GROUP	MODEL
Voluntary Emissions Service Campaign	2024MY Multiple Models
NUMBER	DATE
SC320	October 2024

VOLUNTARY EMISSIONS SERVICE CAMPAIGN

EGR VALVE ASSEMBLY REPLACEMENT (SC320)

Replacement Procedure: Carnival (KA4)

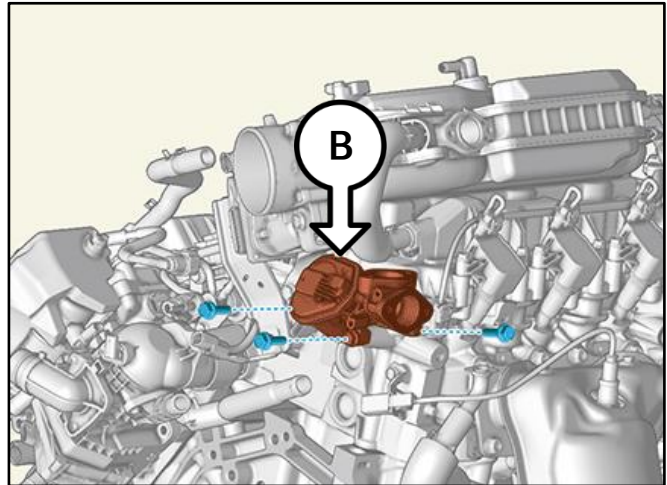
1. Remove the surge tank (A) by referring to "Engine Mechanical System → Intake and Exhaust System → Surge Tank → Removal and Installation" in the applicable Shop Manual on KGIS.

2. Replace the Exhaust Gas Recirculation (EGR) Control Valve (B) by referring to "Emission Control System → Exhaust Emission Control System → EGR (Exhaust Gas Recirculation) → Removal and Installation" in the applicable Shop Manual on KGIS.

Tightening torque for EGR Bolts:
13.7 - 17.4 lb.ft (18.6 - 23.5 N.m)

EGR VALVE ASSEMBLY REPLACEMENT (SC320)**Replacement Procedure: Sportage (NQ5)**

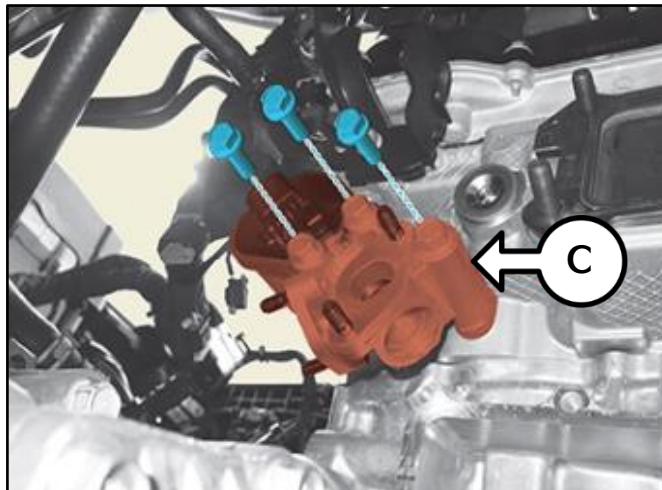
1. Replace the EGR Valve Assembly (C) by referring to "Emission Control System → Exhaust Emission Control System → Electrical Exhaust Gas Recirculation (E-EGR) Control Valve → Removal and Installation" in the applicable Shop Manual on KGIS.

Replacement Procedure: Niro P/HEV (SG2 P/HEV)

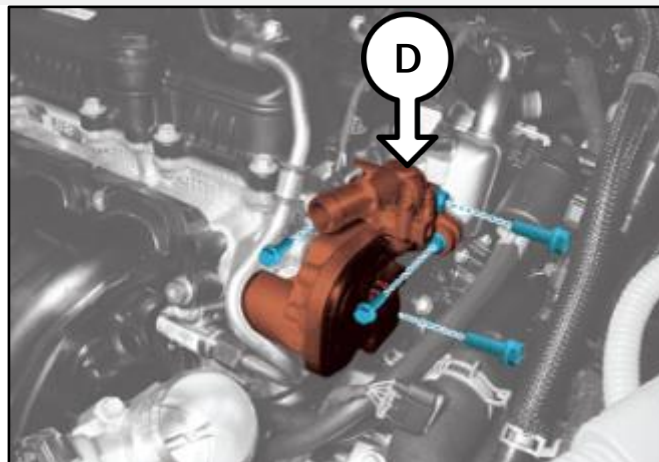
1. Replace the EGR Valve Assembly (D) by referring to "Emission Control System → Exhaust Emission Control System → Electrical Exhaust Gas Recirculation (E-EGR) Control Valve → Removal and Installation" in the applicable Shop Manual on KGIS.
